Regional Municipality of Durham

Bid Opportunity: T-1032-2021 – Relocation of Oral Health Clinic to 200 John Street, Oshawa

Addendum number 2 – May 6, 2021

1 LOW VOLTAGE LIGHTING CONTROL SYSTEM WIRING SCHEMATIC
E-006 SCALE: NTS

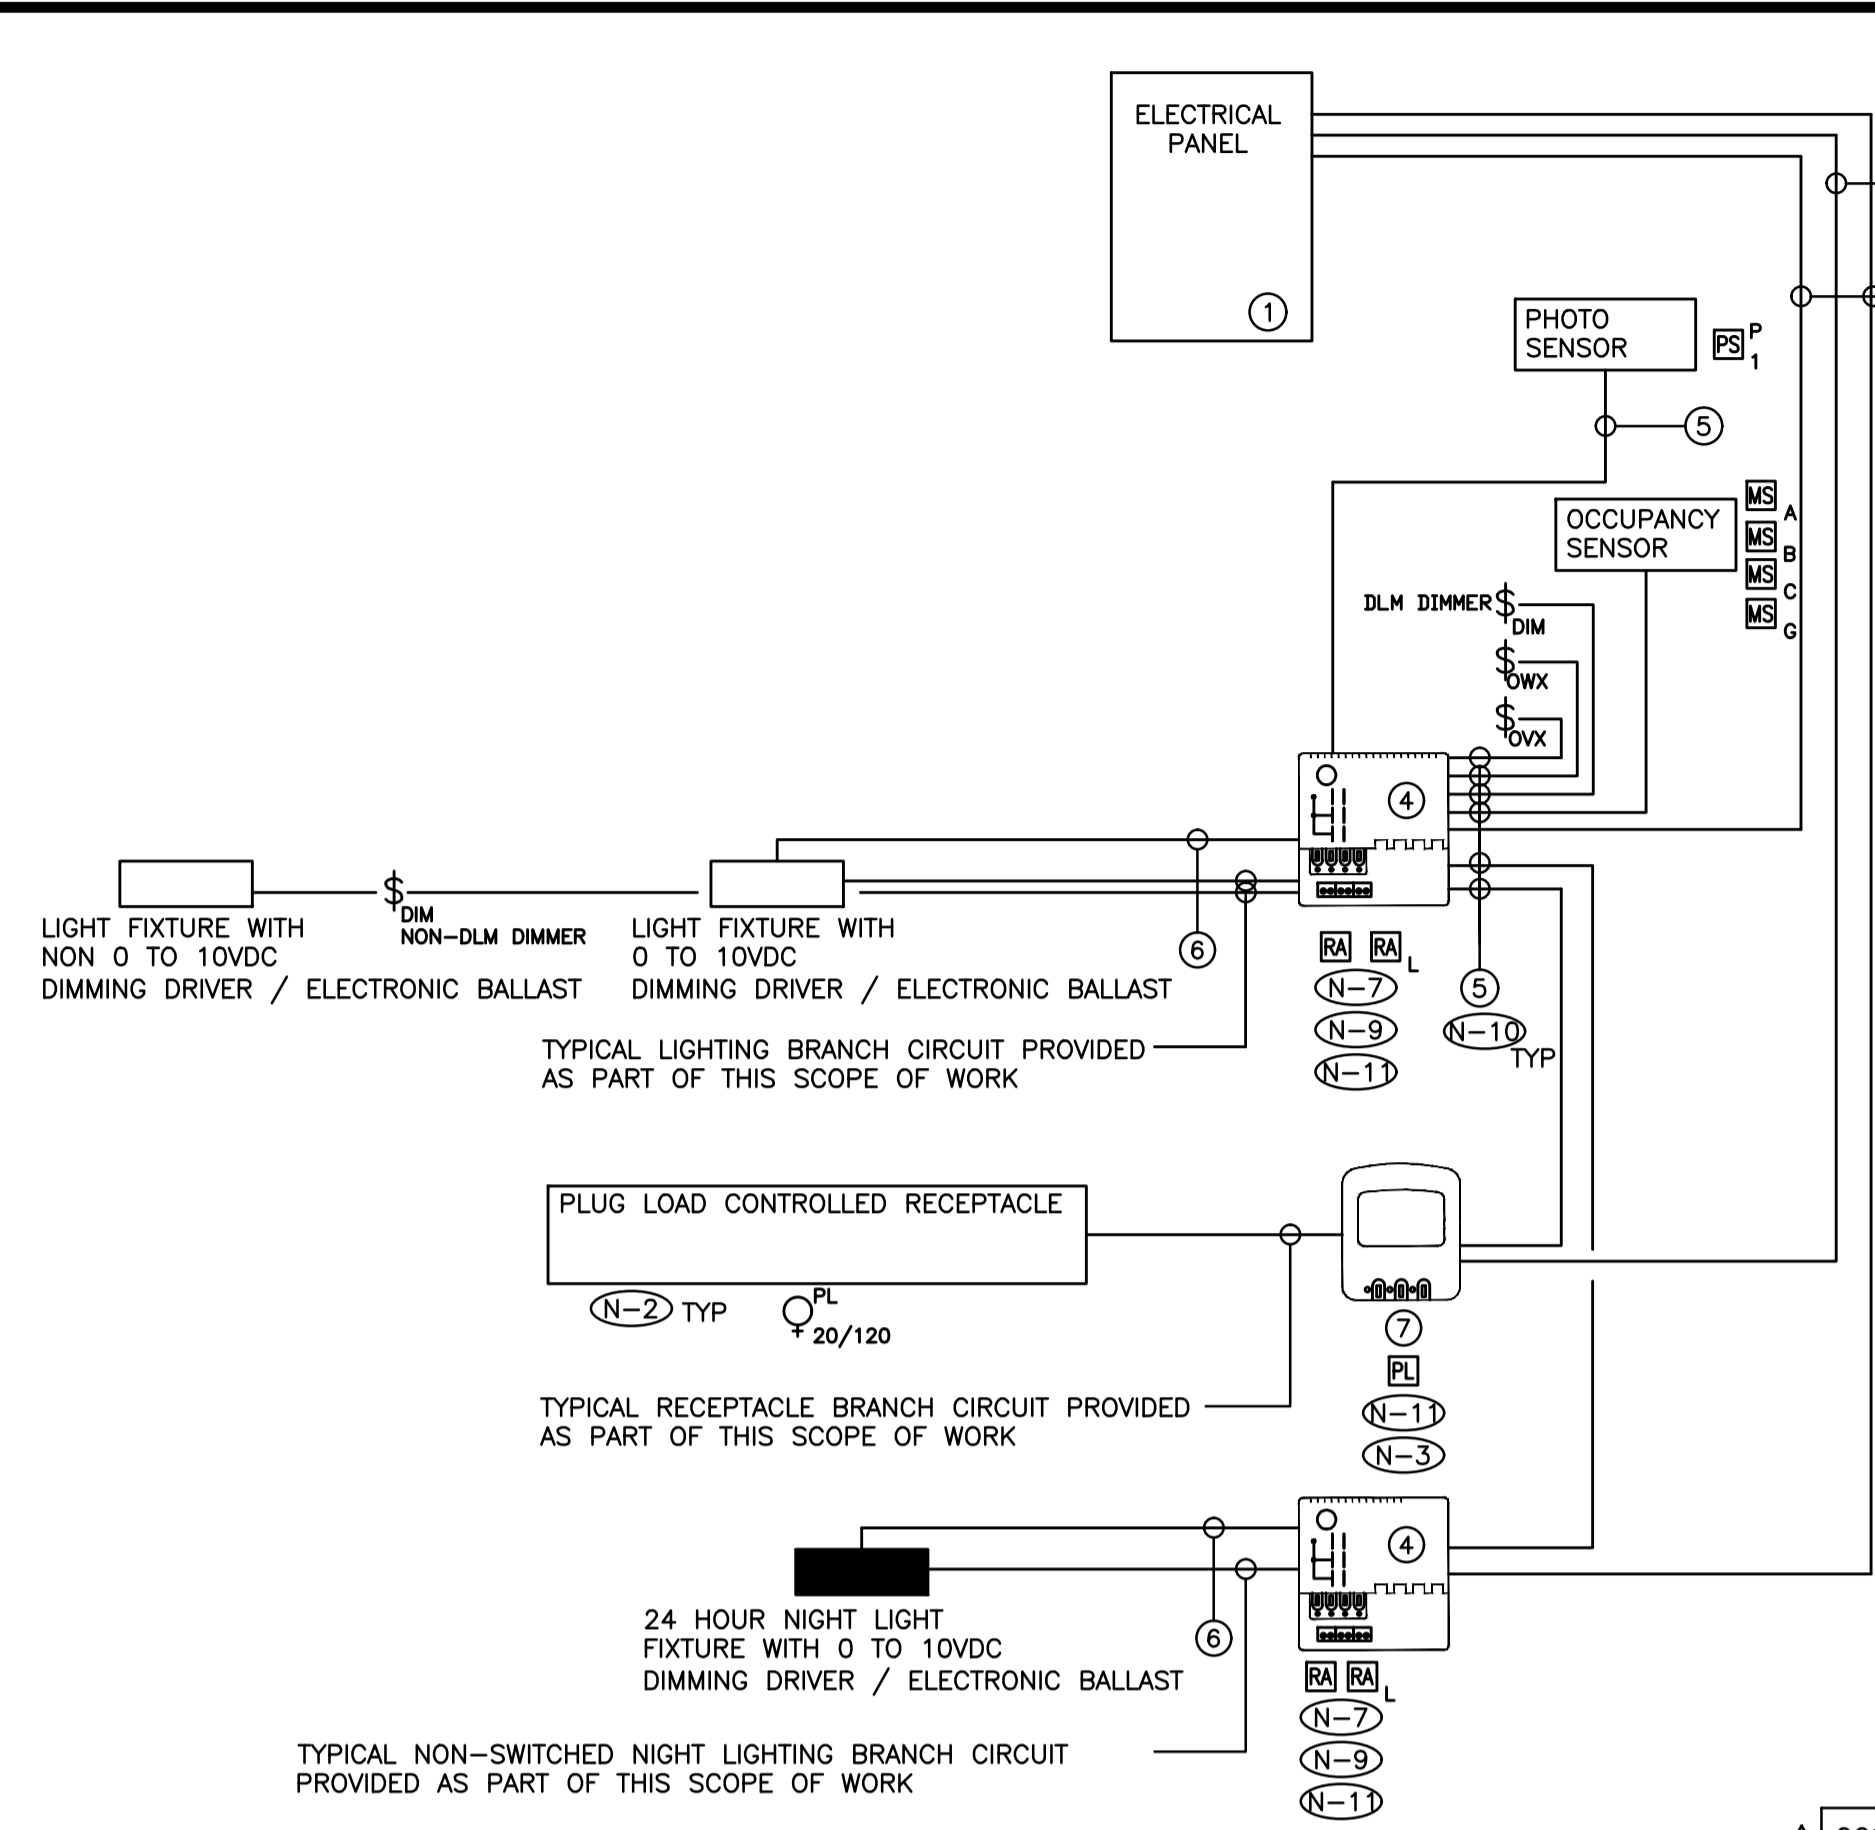
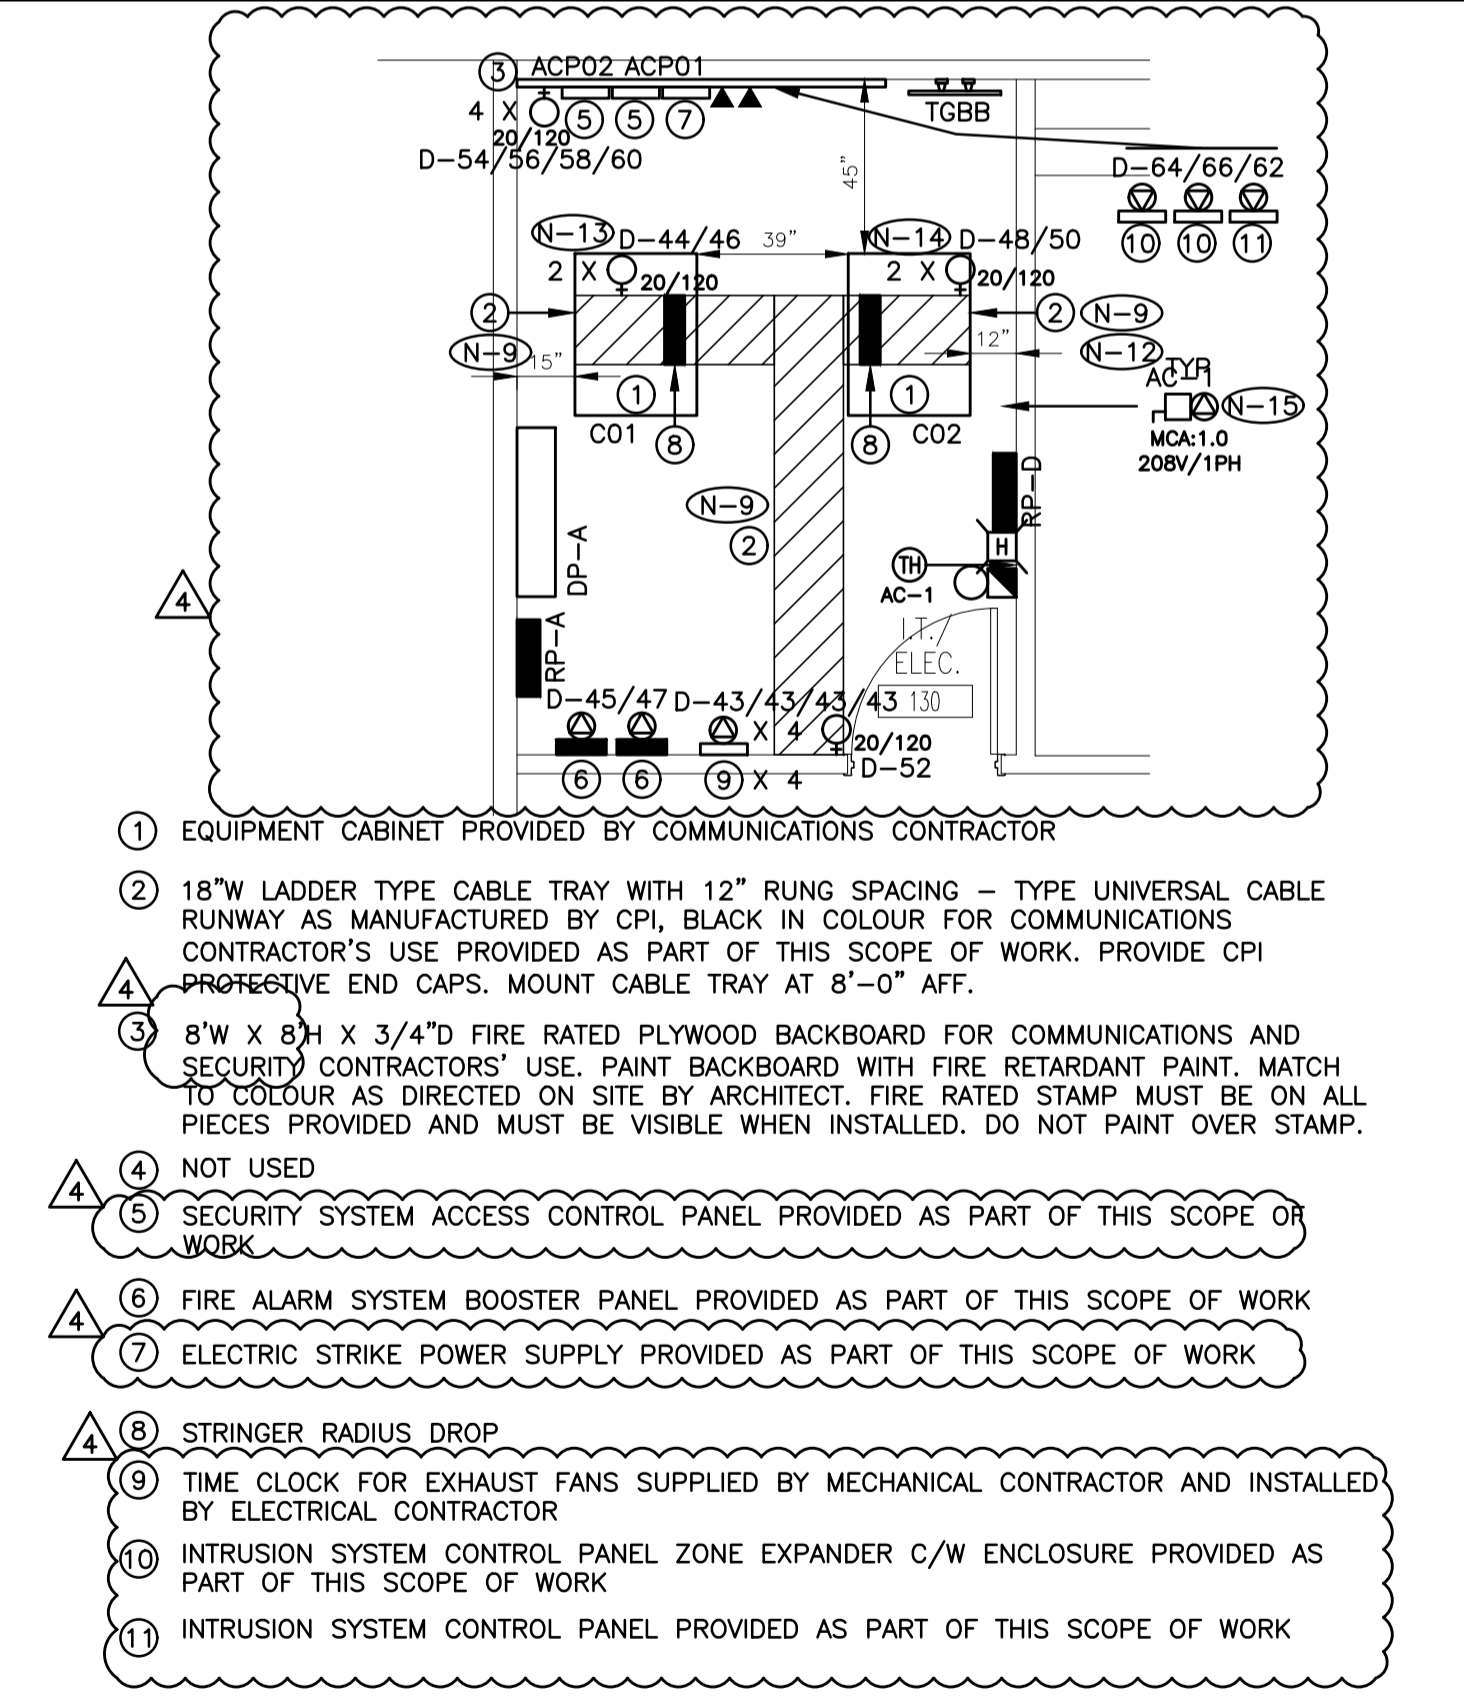
- .5 Drawing E-006 has been modified as part of this addendum.
 - .1 Updated details number 1, 2 and 3.

1 X-RAY ELECTRICAL REQUIREMENT DETAIL
SCALE: N.T.S.

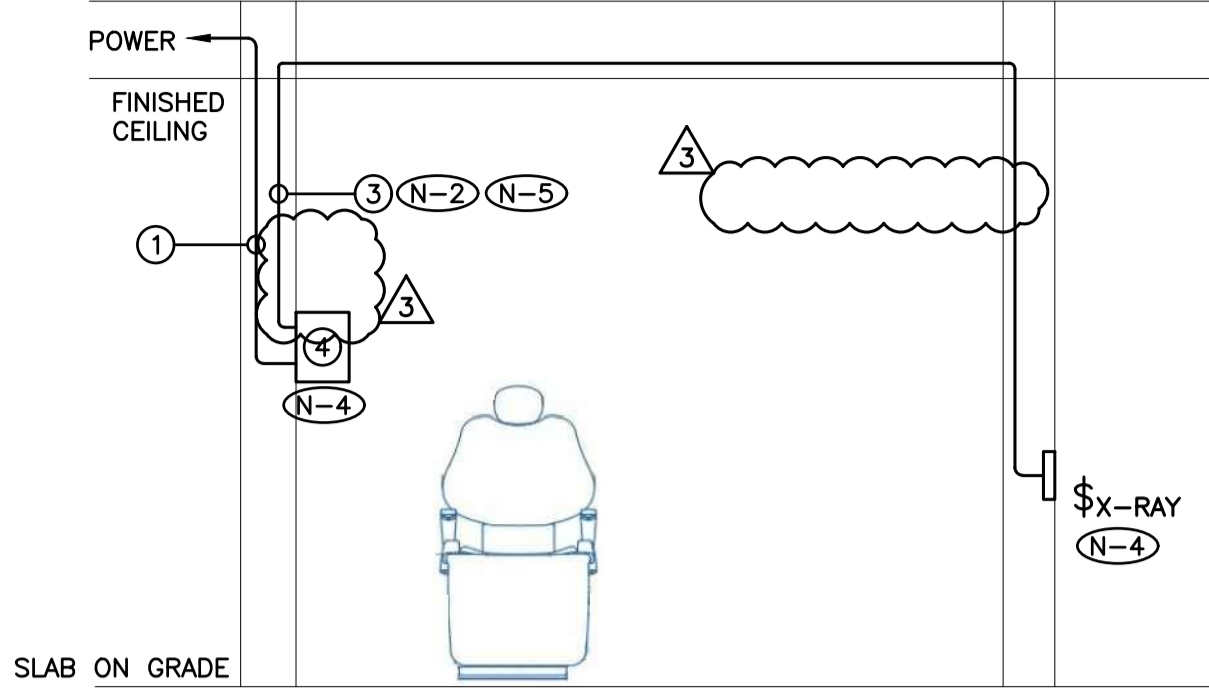
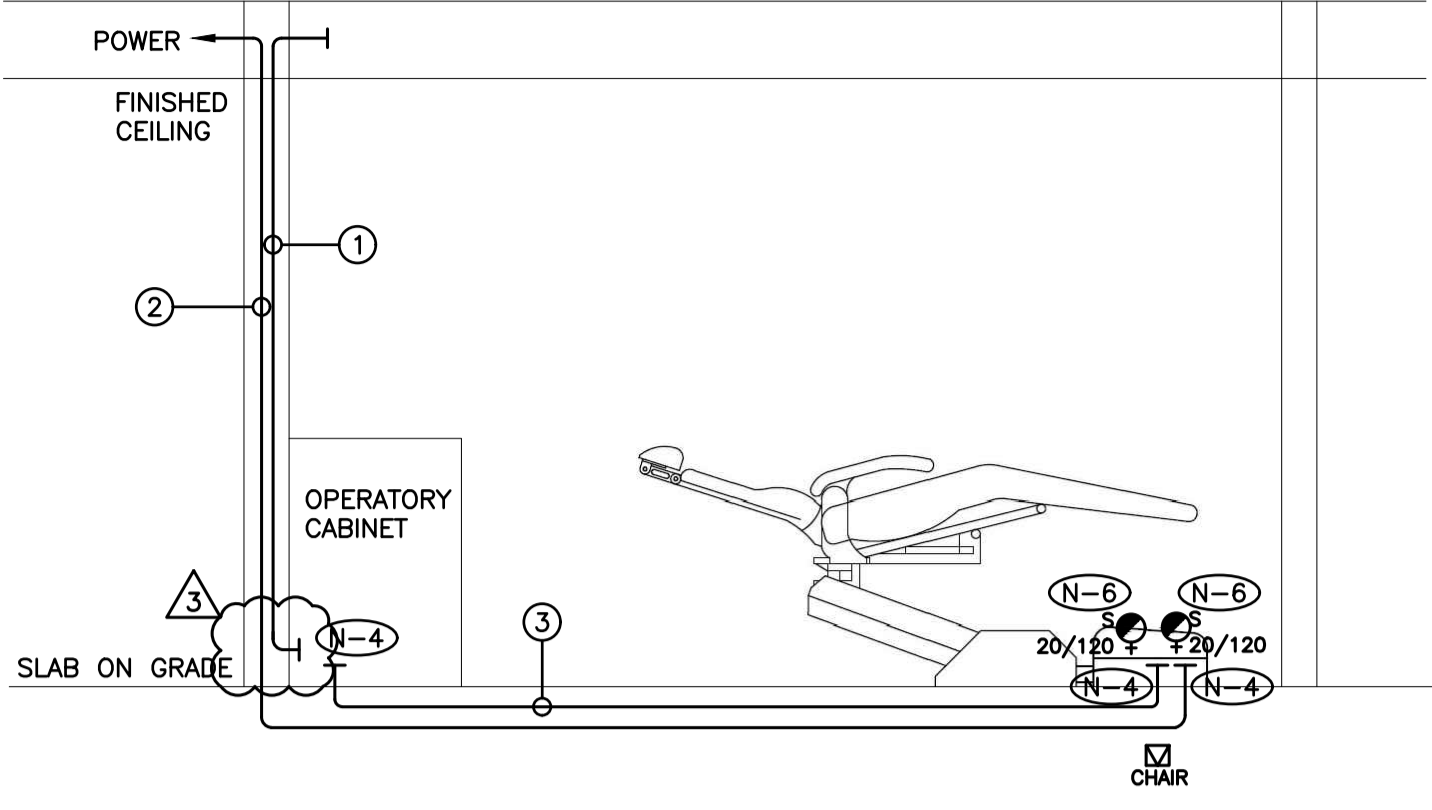
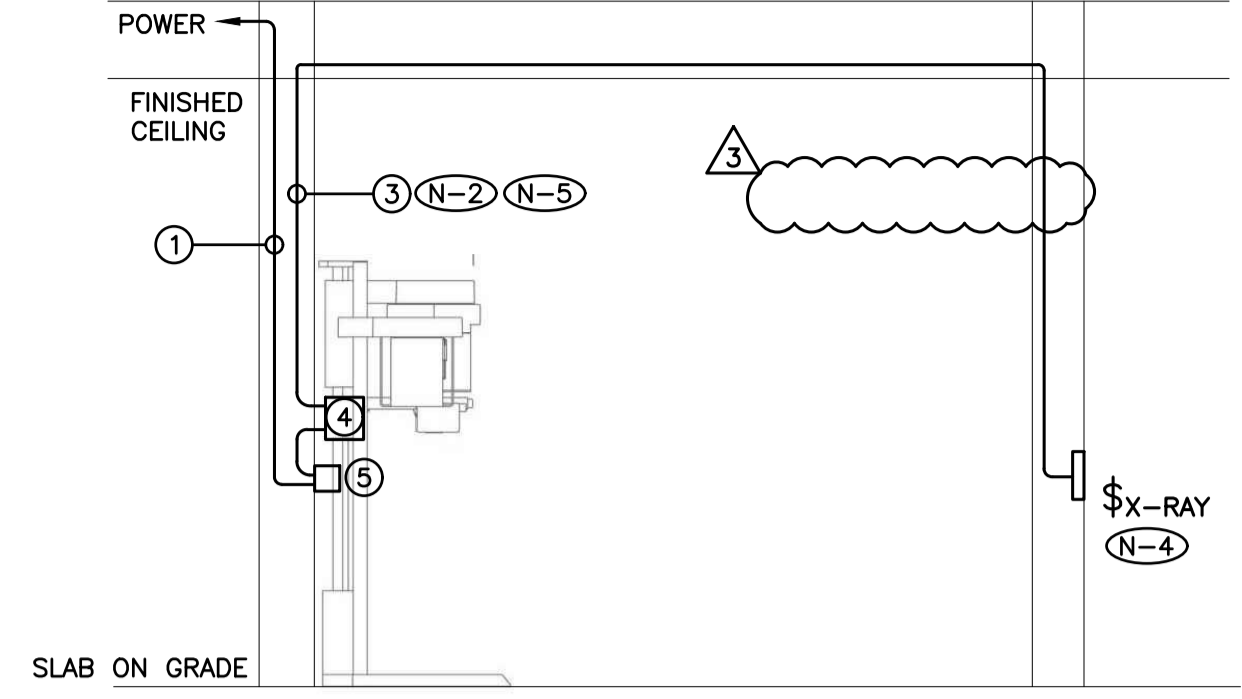
- .6 Drawing E-007 has been modified as part of this addendum.
 - .1 Updated details number 1, 2, 3 and 4.
